STAFF RECOMMENDATION
1010 Lawrence Avenue
August 16, 2017

Metropolitan Historic Zoning Commission
Sunnyside in Sevier Park
3000 Granny White Pike
Nashville, Tennessee 37204
Telephone: (615) 862-7970
Fax: (615) 862-7974

Application: New construction – outbuilding
District: Waverly-Belmont Neighborhood Conservation Zoning Overlay
Council District: 07
Map and Parcel Number: 11801019600
Applicant: Holly W. Coleman, Owner
Project Lead: Sean Alexander, sean.alexander@nashville.gov

Description of Project: The applicant proposes a revision to a proposal to construct an outbuilding that was approved by the MHZC in June 2017. The outbuilding will be located eleven feet (11') from the back of the house. The design of the building is otherwise identical to what was approved.

Site Plan

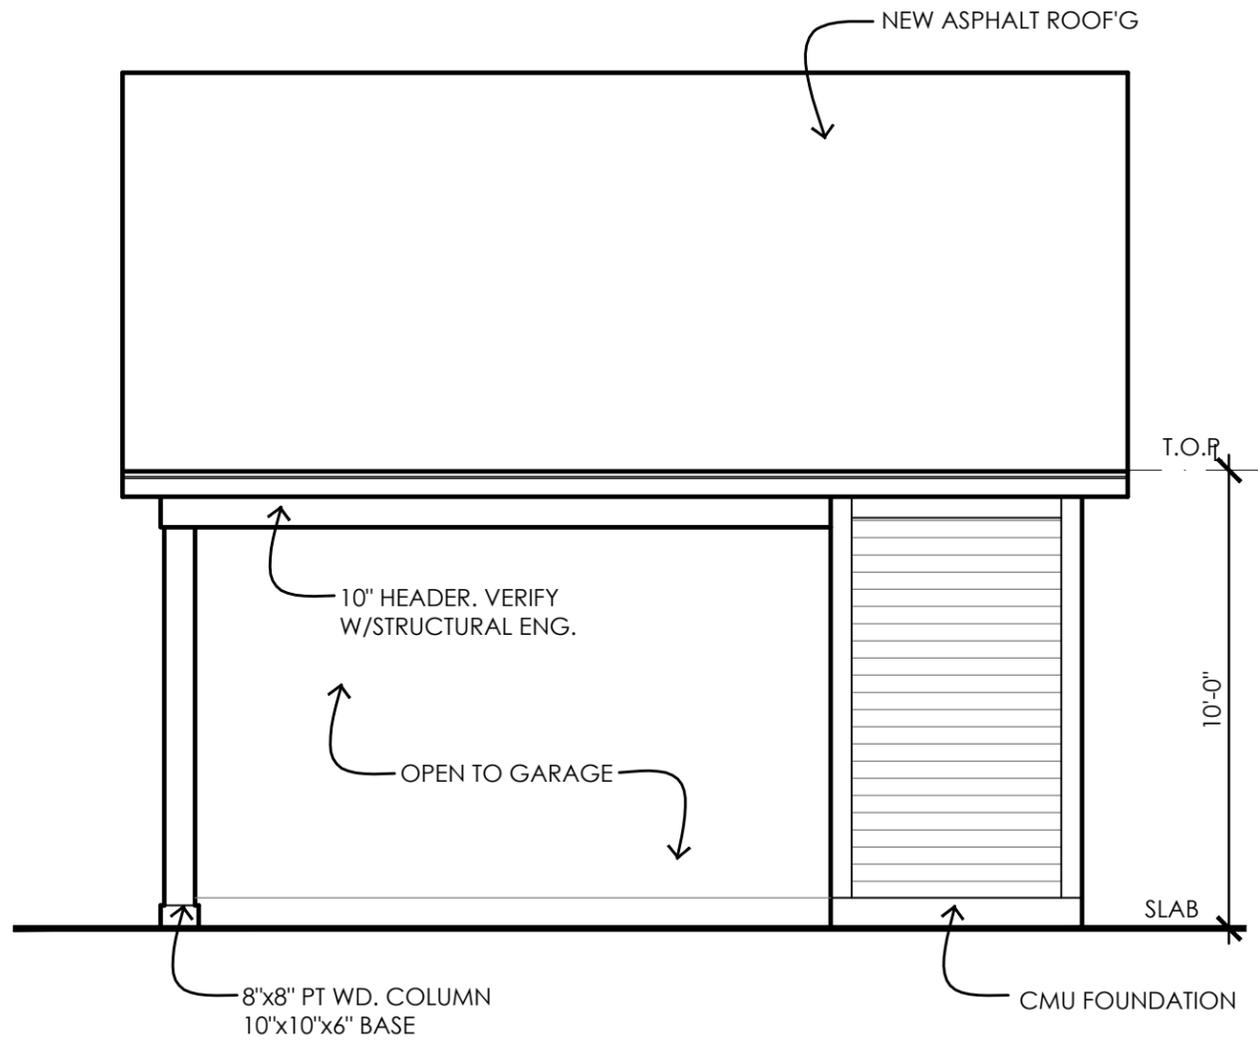
Analysis and Findings: The applicant proposes to construct a new outbuilding located eleven feet (11') from the rear of the house. The proposed outbuilding will be open on three sides, with a garage door on the alley facing elevation.

MINIMUM	PROPOSED
Space between principal building and DADU/Garage	20'	11'
Rear setback	10'	5'
L side setback	3'	5'
R side setback	3'	20'
How is the building accessed?	From the alley or existing curb cut	From the alley at the rear

The standard minimum setback for the façade of an outbuilding with a garage door facing an alley is ten feet (10'), however the proposed outbuilding would be located only five feet (5') from the rear of the property. The outbuilding will be only eleven feet (11') from the rear of the principal building, shorter than the twenty foot (20') requirement in the design guidelines. Staff finds the location to be appropriate because the building will be in the location of outbuildings historically. Additionally, the historic house is relatively narrow and deep and the recently approved addition is narrower than the historic house, whereas the conditions of the lot may have warranted an addition to be wider. Together this results in leaving a shallow back yard for an outbuilding on the one hundred, fifty foot (150') deep lot. Staff finds the proposed outbuilding location is in keeping with the typical location of buildings historically and the separation is appropriate because the historic house is so deep, and therefore the project meets sections III.H.6 and III.H.7 of the design guidelines. The building will not be used as a Detached Accessory Dwelling Unit.

Recommendation: Staff recommends approval of the project with the condition that Staff shall approve the window and door selections prior to purchase and installation. With that condition, staff finds that the project meets the applicable sections of the *Waverly Belmont Neighborhood Conservation Zoning Overlay: Handbook and Design Guidelines*.

A FRONT ELEVATION AT GARAGE
 SCALE: 1/4" = 1'-0"

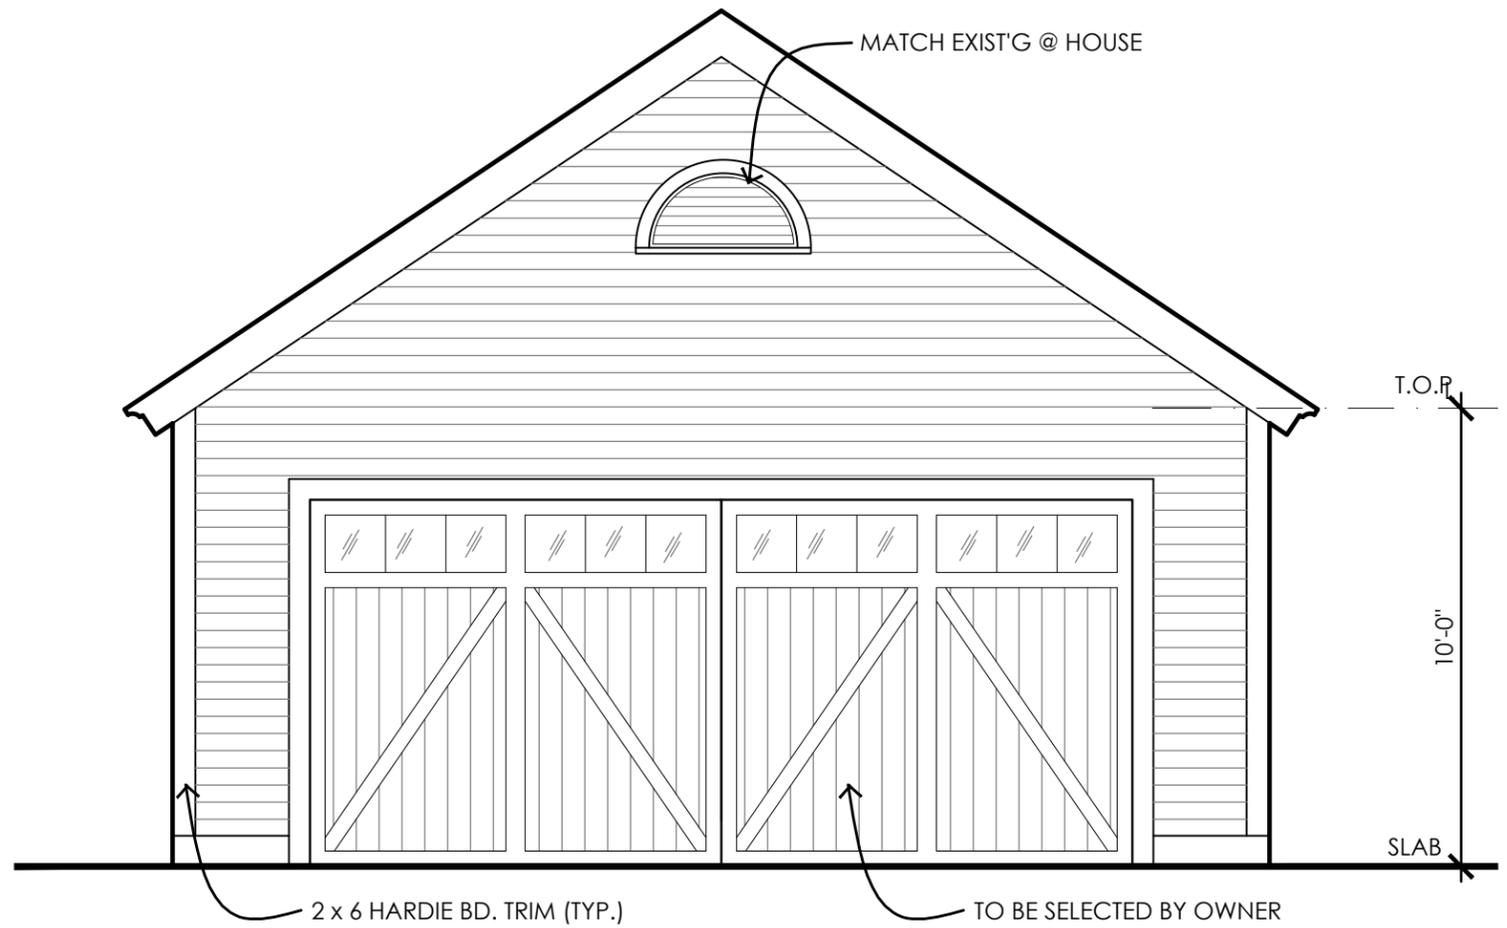
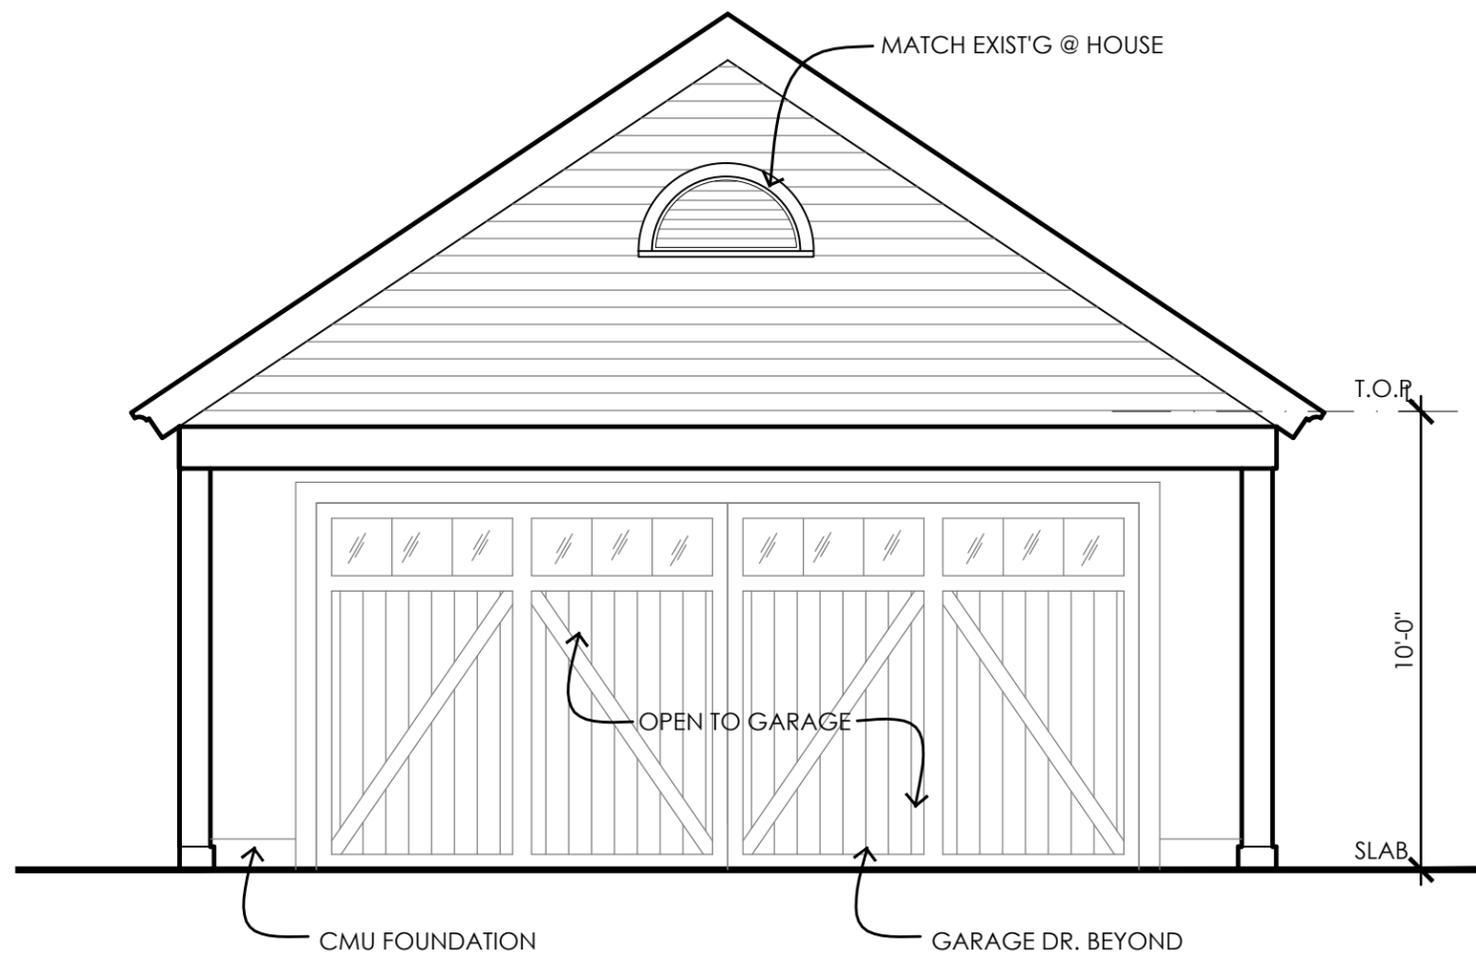
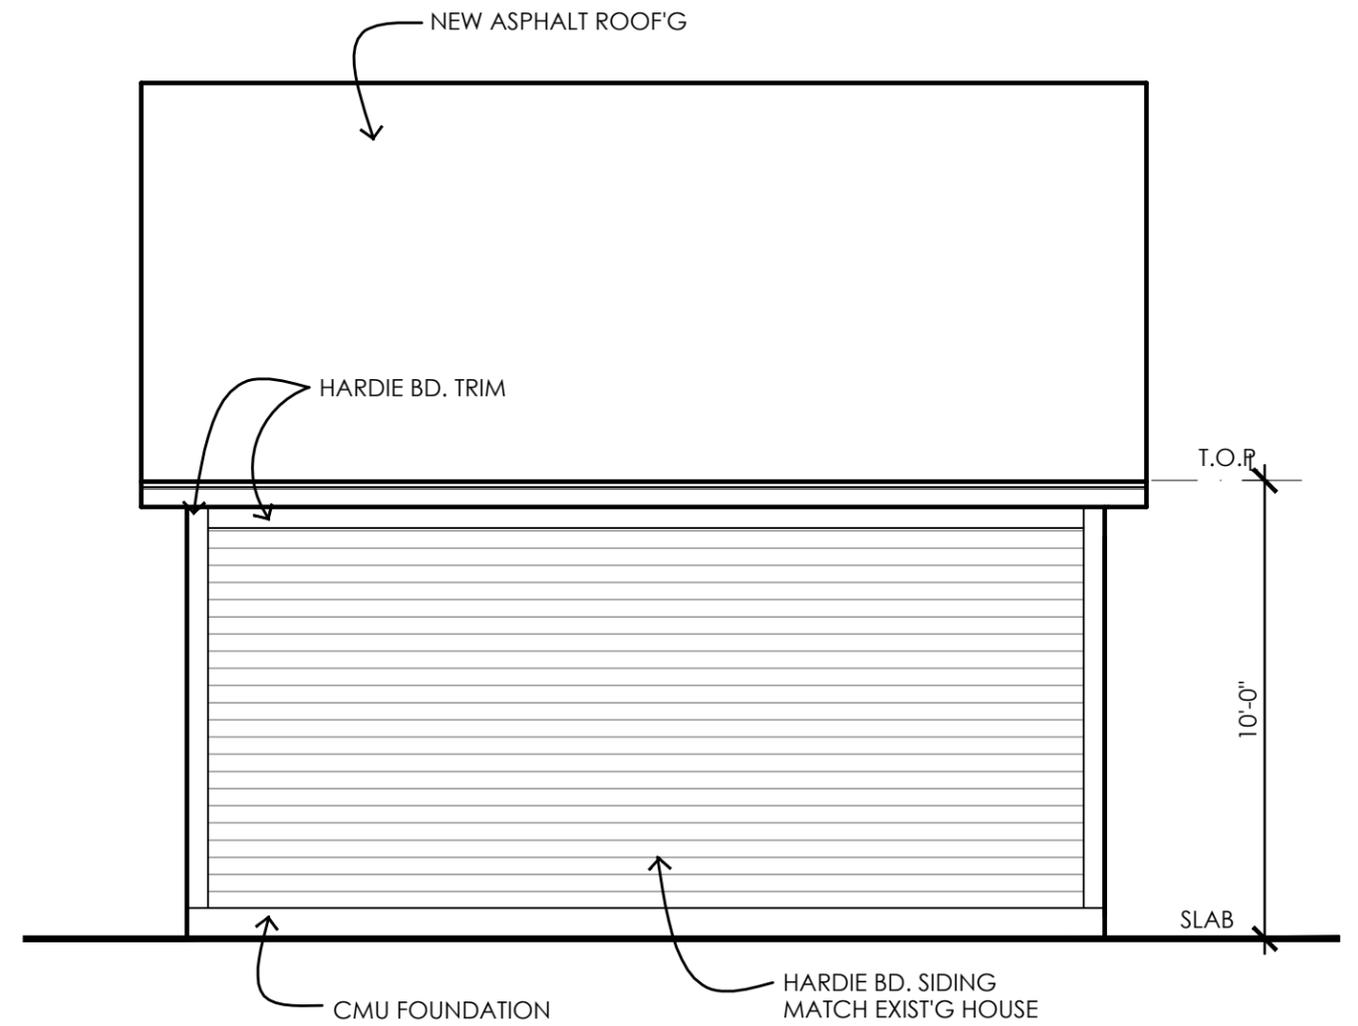
Apart from the distance between the house and the outbuilding, the design of the proposal will otherwise be identical to the outbuilding that was approved in June 2017. The building was found to meet the design guidelines for scale, roof, and materials with the condition that the windows and door selections are administratively approved.
